Product Change Notification

PCN-MI-696-2017

Description for Product Change Notification

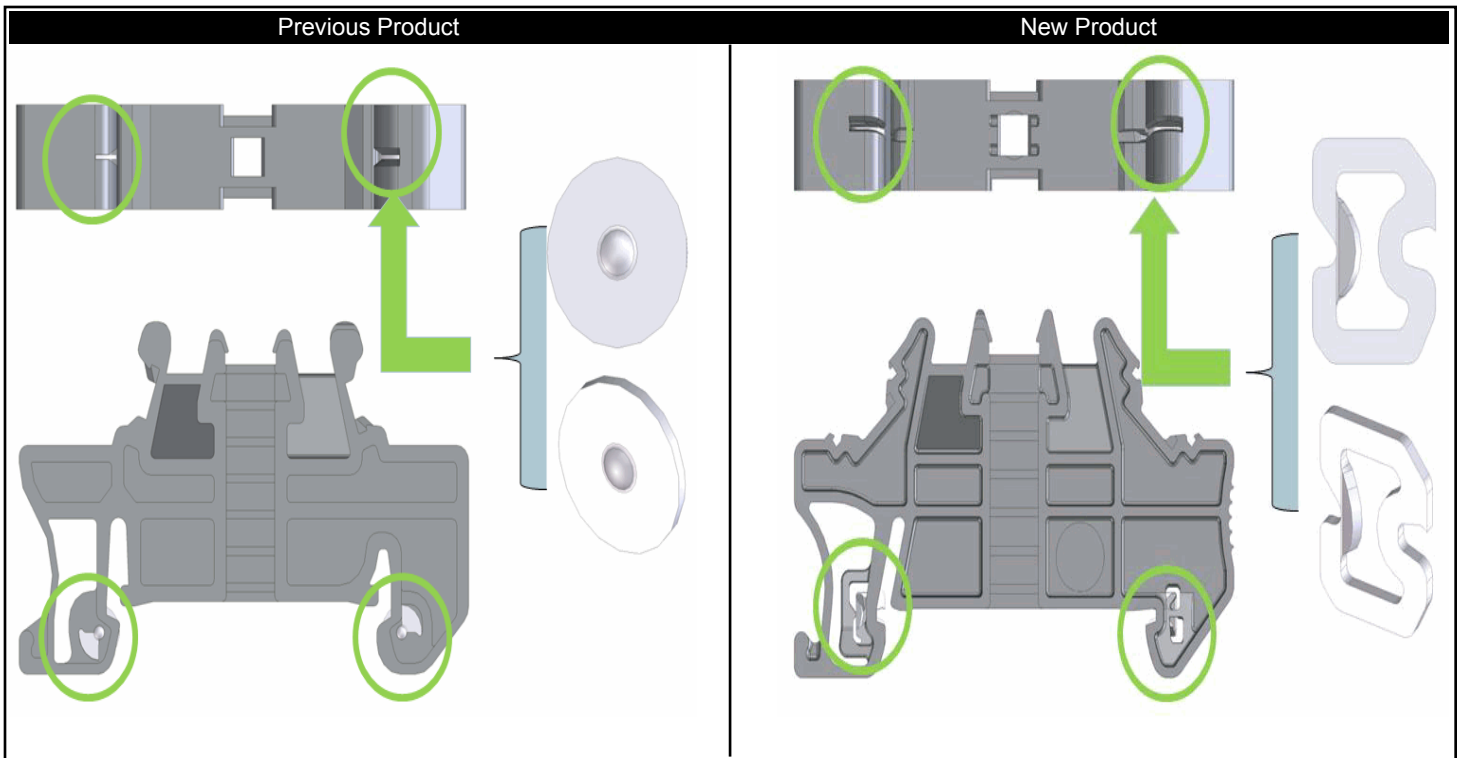
- These modifications include the following changes:
- The displacement force is optimized due to angular metal parts and the shape of the metal
 - Additional marking possibility for TMT (EX9,5)R [0828295]
 - Slight changes of the design due to tool optimizations
